Access Compliance Report Public Rights-of-Way (Curb Ramps)

Main Street: FLINTRIDGE_AVE		Cross Street: WELDON_HEIGHTS		Location:	SW
ADA ID: RPRK211108120959	Ramp Type:Type 1 - Perpendicular	Initial Pass/Fail: Pass	Overall Compliance: No	Severity Score:	16
Codes/Mitigation Info/Possible Solution			Field Measurements/Component Compliance

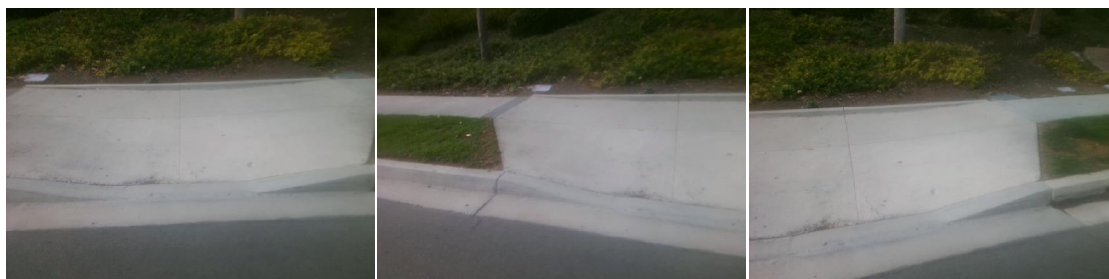
R304.2.2, R204.3, R304.2.2-Perp, R304.3.2-Para, R305, R304.5.4, R304.5.3, STD 1115

Remove & Replace Entire Ramp. Remove & Replace Gutter.
